STATE OF WASHINGTON  
DEPARTMENT OF ECOLOGY

**Re: Opinion pursuant to WAC 173-340-515(5) on Remedial Action for the following Hazardous Waste Site:**

- **Site Name:** Seitz Property
- **Site Address:** Brian Lane NW, Silverdale, Washington 98383
- **Facility/Site No.:** 6865393
- **Cleanup Site ID:** 1472
- **VCP Project No.:** NW3313

Pursuant to completion of the RI work described in *Remedial Investigation Report*, dated October 19, 2021 (*October 2021 RI*), is additional work necessary to resolve data gaps?

**FIGURE**  
 3

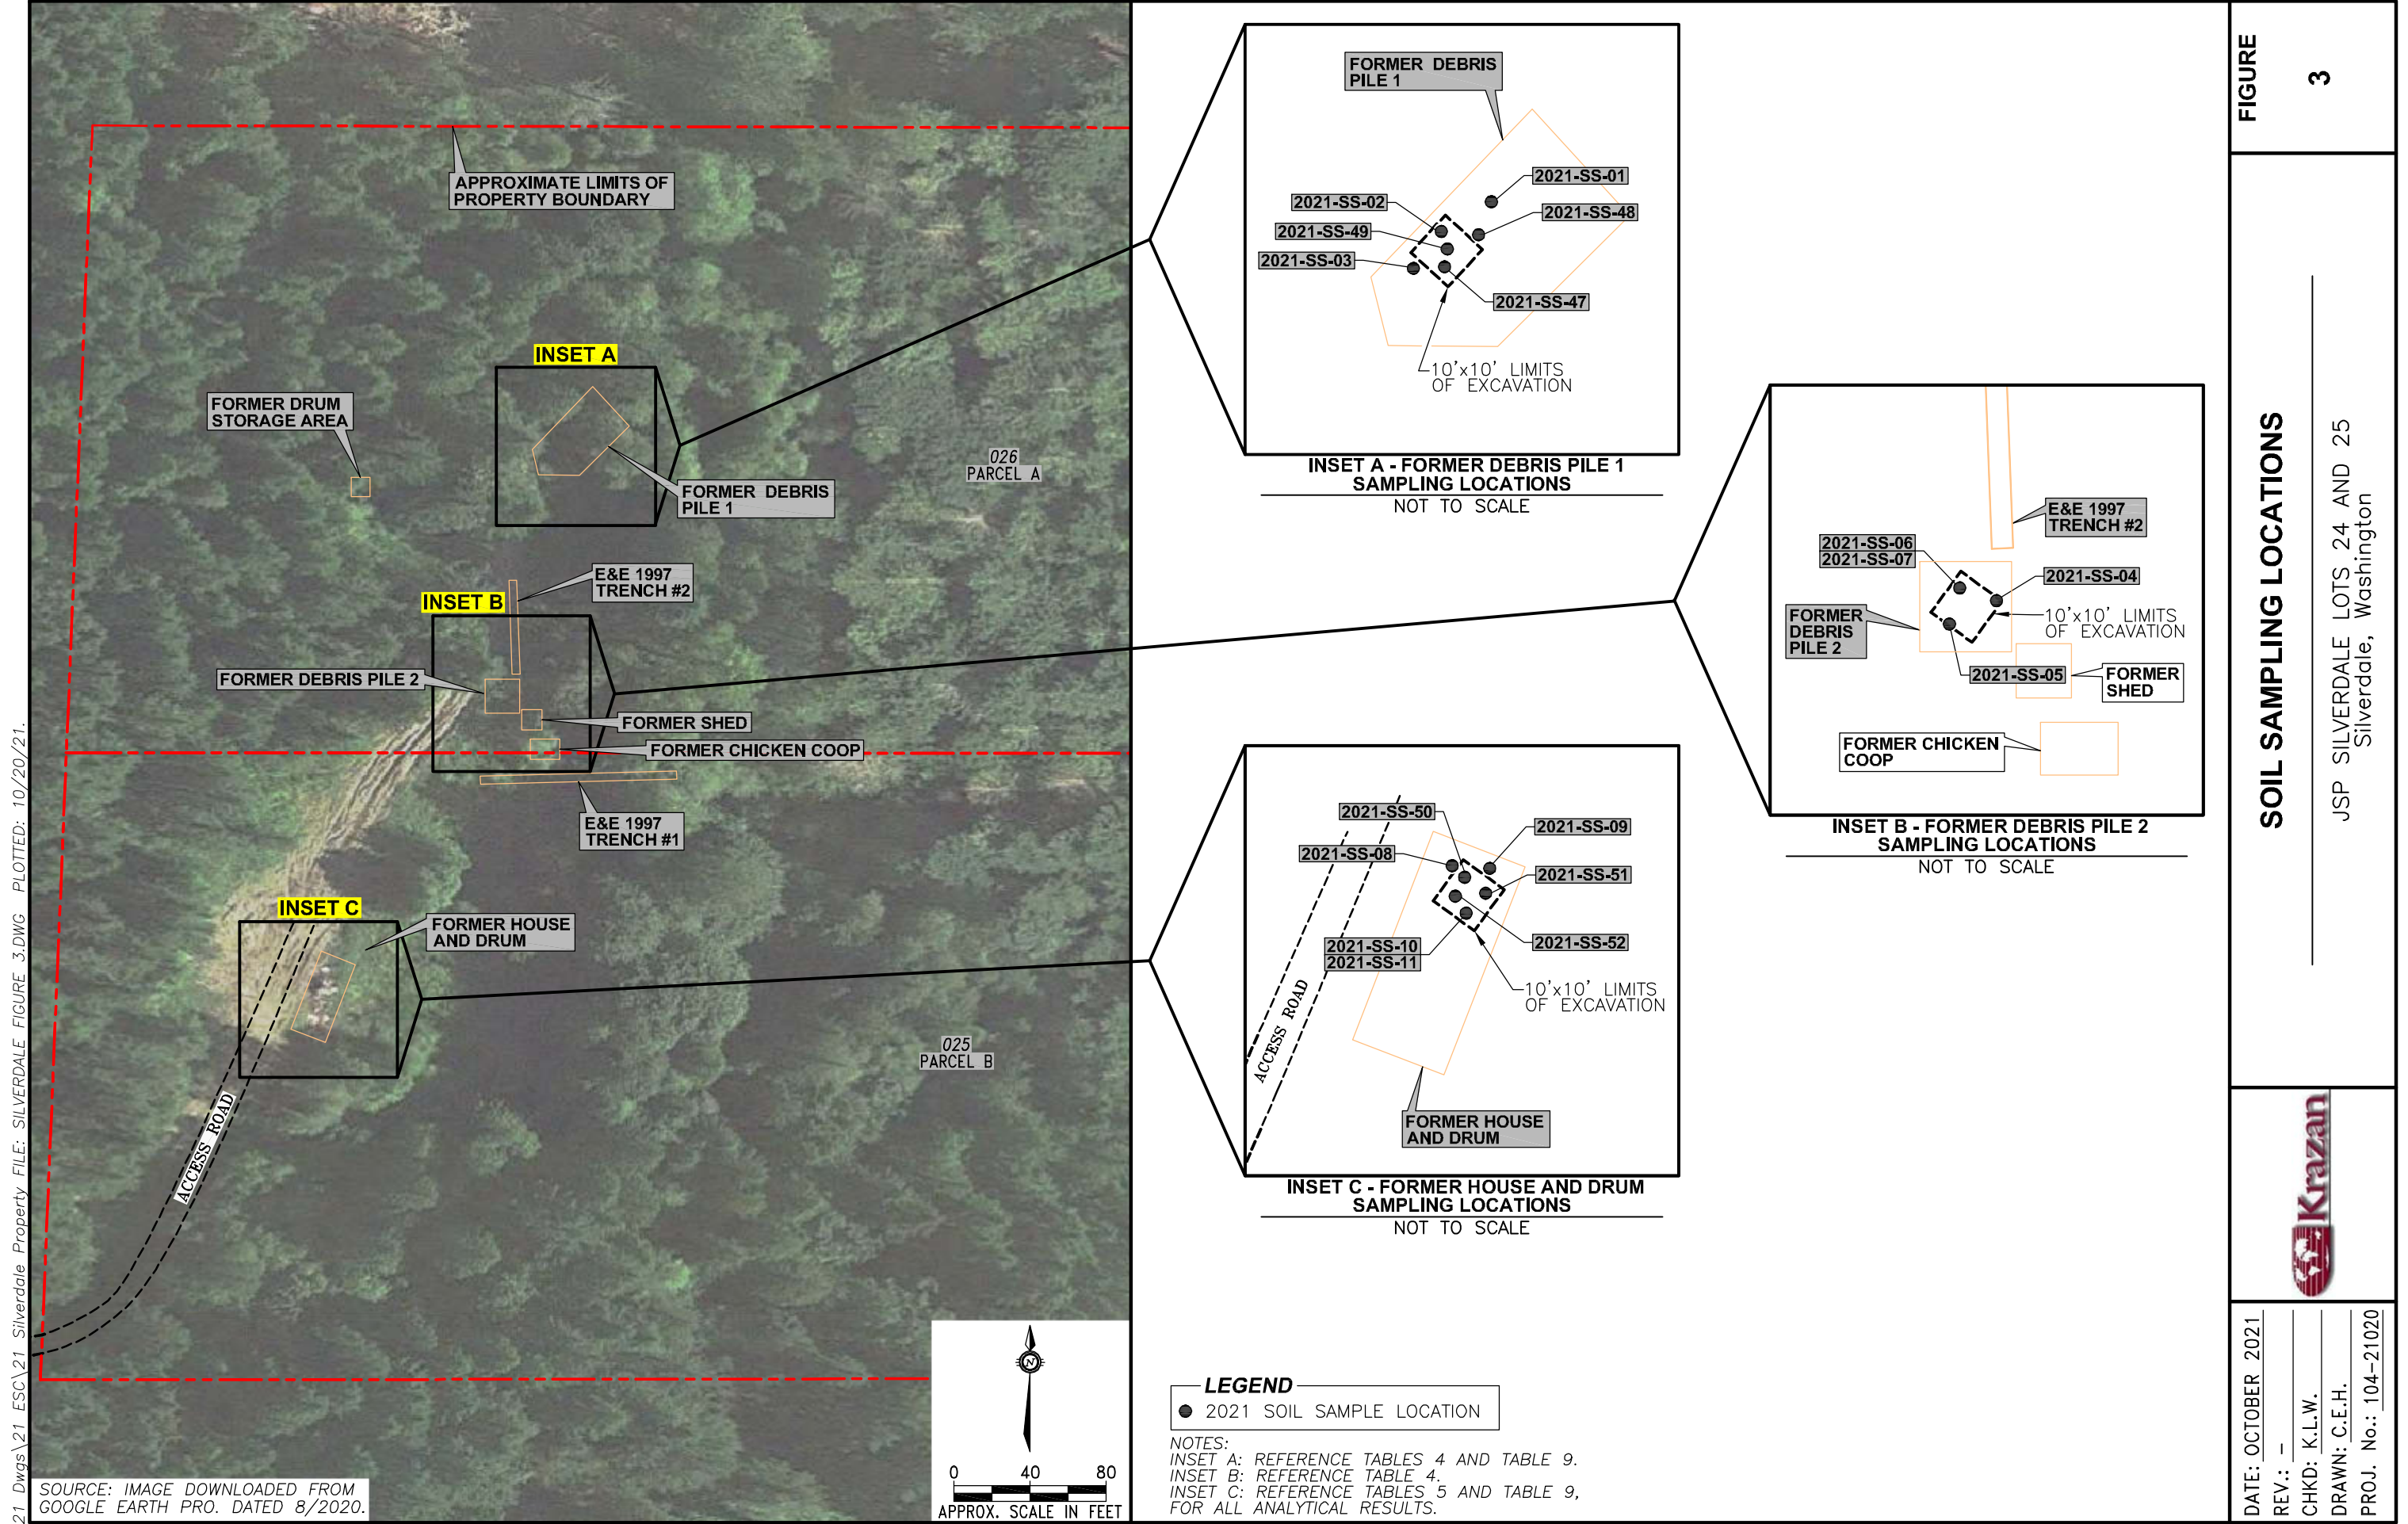
- Figure 3 of the *October 2021 RI* depicted the soil sampling locations in 2021. However, the surface soil sampling locations SS-12 through SS-14, collected in the former drum storage area, are not shown on Figure 3. Please update Figure 3 with these soil sampling locations.
- Please provide groundwater elevation contour maps for each groundwater monitoring event, and a Rose Diagram showing the variation of groundwater flow directions.
